Consultee Comments for Planning Application APP/19/00911

The following comments have been received from Landscape Civil Engineering & Landscape Team at Havant Borough Council on 04/10/2019. Responses to the comments are shown red:

Proposed site plan indicating TPO, potential areas of soft landscaping/vegetation, dimension between parking bays 1 & 2 and between parking bay 5 & the proposed development.

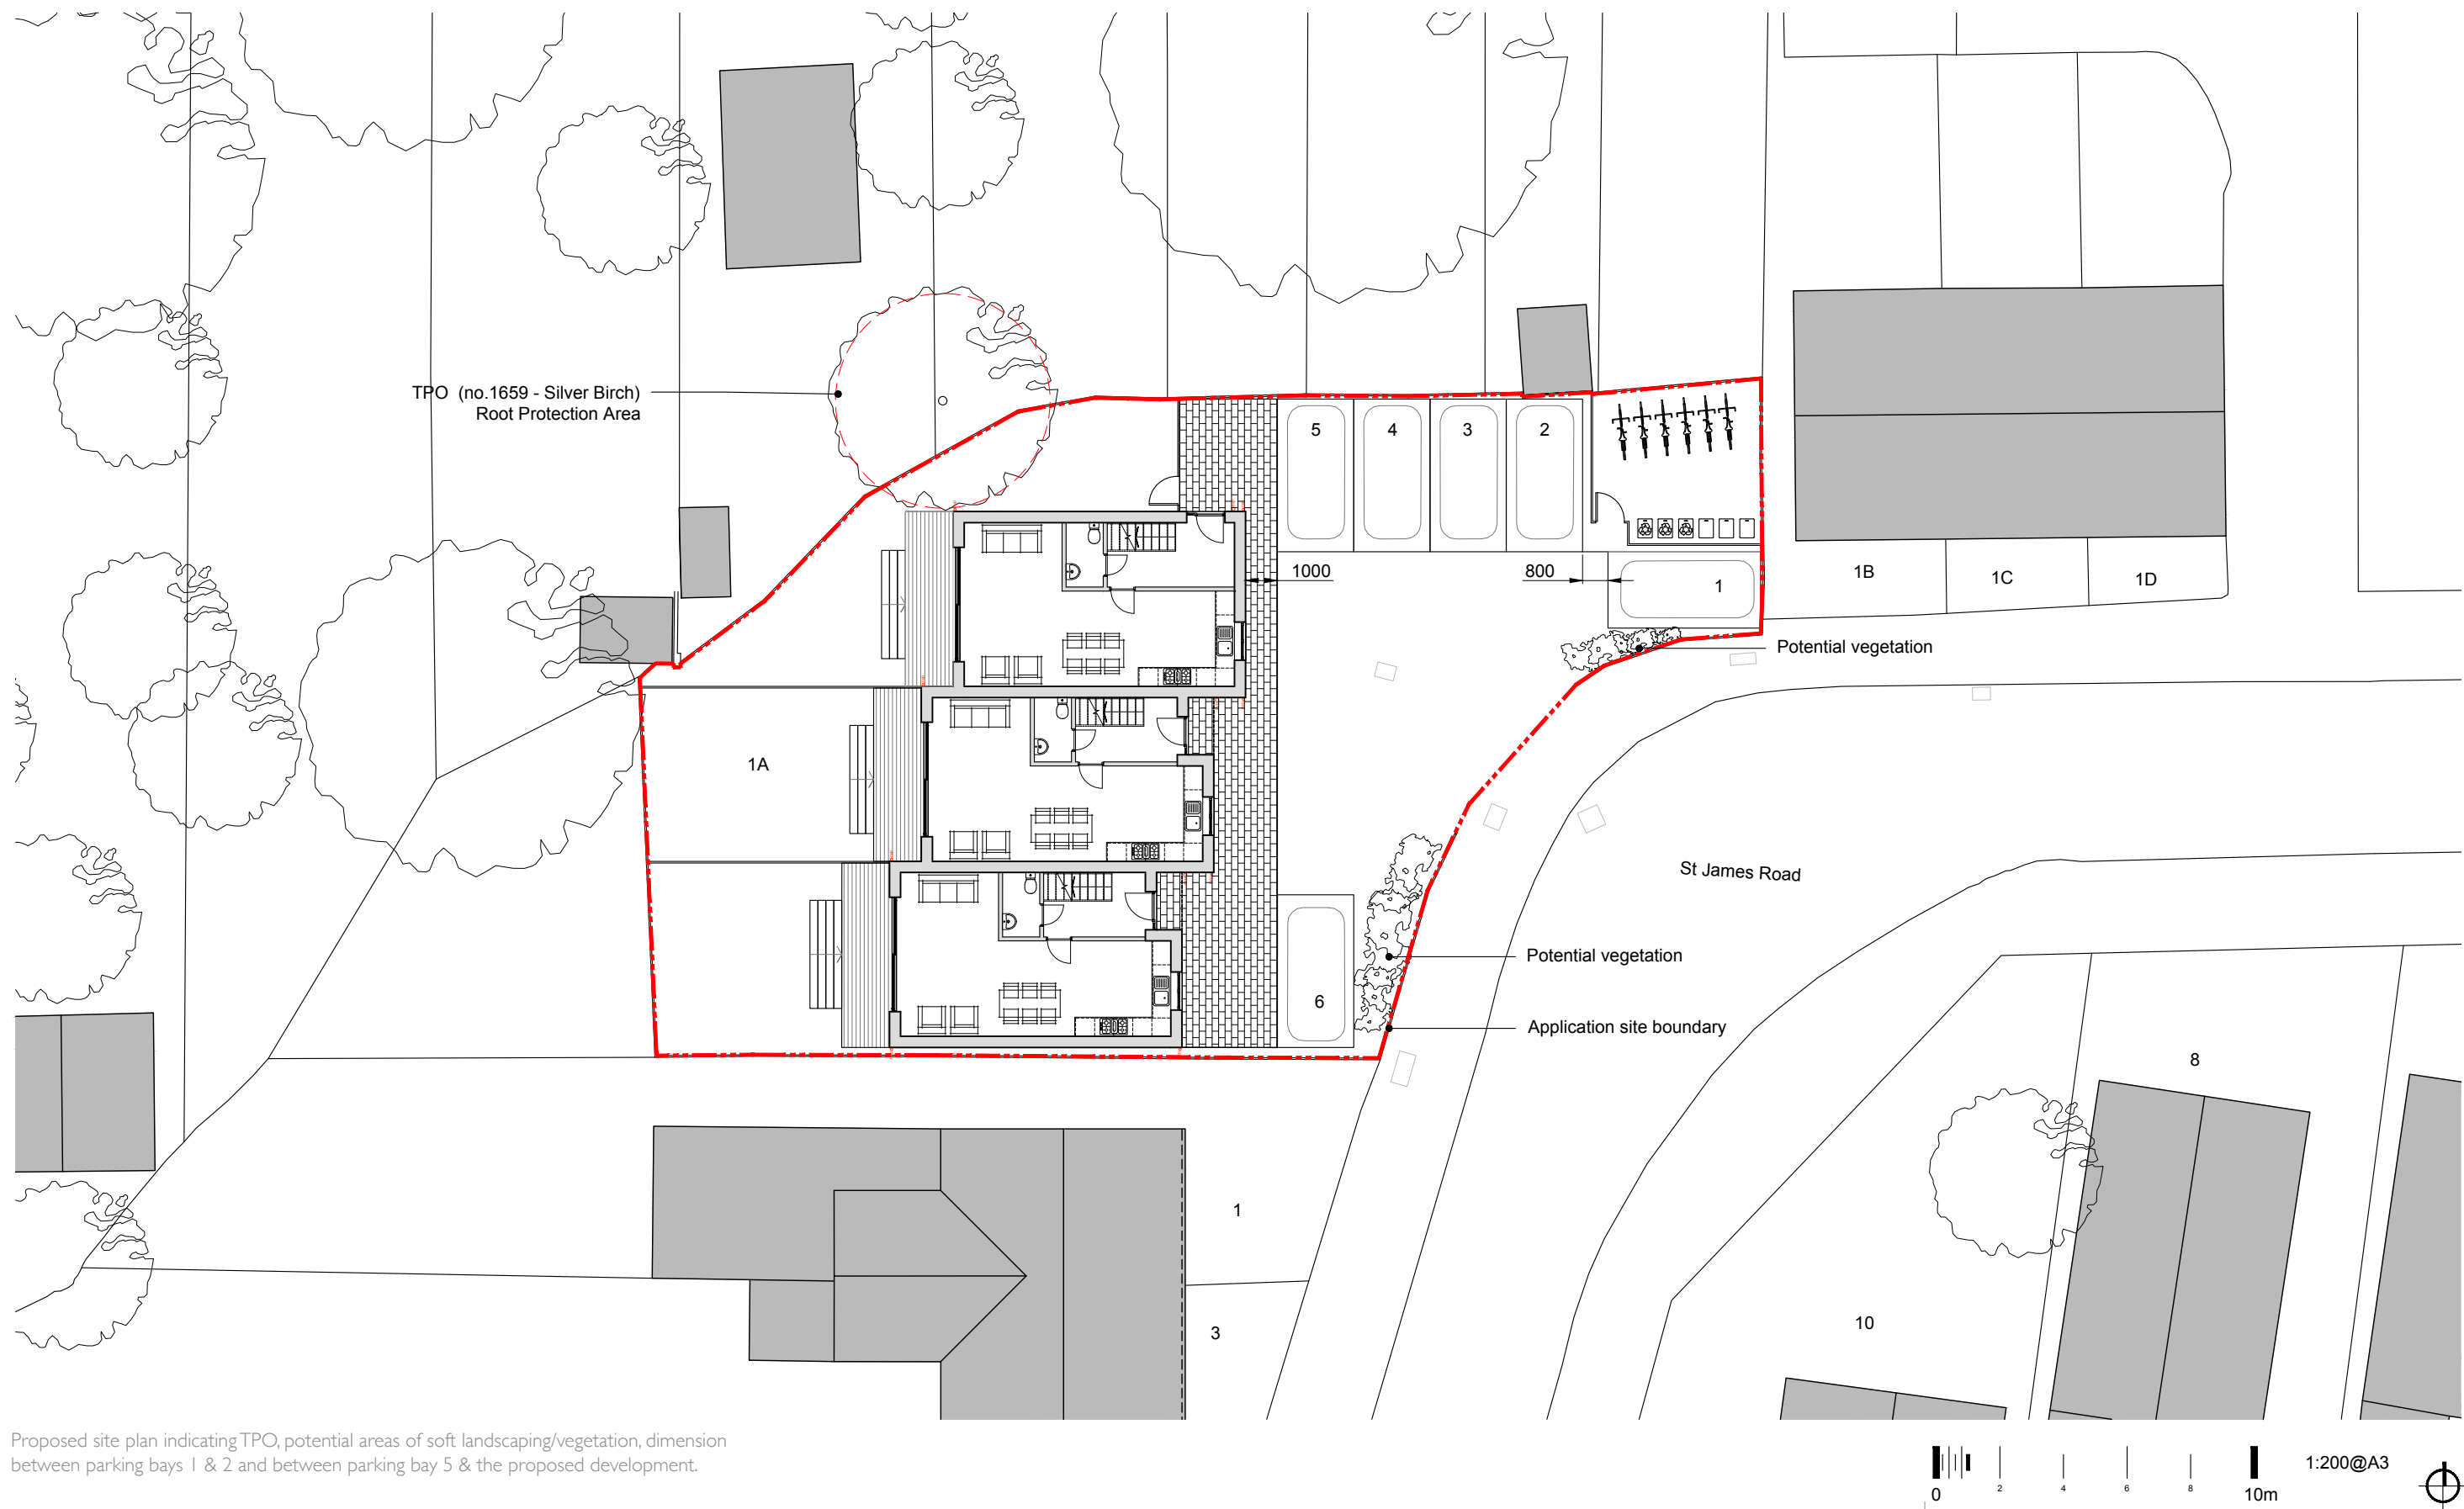
*- “We have concerns with the amount of space allocated for access/egress of the bike and bin storage. The space provided between parking bays 1 and 2 is too narrow to allow a bike to easily pass through, this could cause a tension and needs to be amended.” As indicated on the attached site plan, the distance shown between parking bays 1 and 2 is 800mm wide, allowing for sufficient room to allow both bikes & bins to pass through. This has been based on the following dimensions: 585mm wide by 730mm long bin & 535mm wide by 1750mm long bike.*

*- “There are a number of trees which abut the site include one TPO tree (no. 1659) whos root protection area (RPA) could be impacted by the proposed development. We require a tree survey to be undertaken to understand the extents of the RPA and ensure there are no detrimental impacts on the trees.” As indicated on an attached site plan, the TPO tree (no.1659) that abuts the site (a Betula Pendula - commonly*

*known as Silver Birch) does not impact the proposed development, because of the relationship of the root protection area (RPA) with the proposed development. According to ‘The British Standard 5837’, RPA is calculated by multiplying the diameter of the tree at breast height in meters by 12, but is capped as an area with a radius of 15m. The RPA for TPO no.1659 is based on a trunk diameter of 270mm, meaning a RPA of 6750mm. Havant Borough Council interactive map has been used to locate TPO tree no.1659, referencing this location against a full Topographical Survey that has been undertaken, indicating the positions of the existing trees. Please refer to comments received from an Arboricultural Officer on 02/10/2019 who has no objection to the proposal: “There is an off site Birch and Oak, however they are not a constraint and I have no objection to the proposal.”*
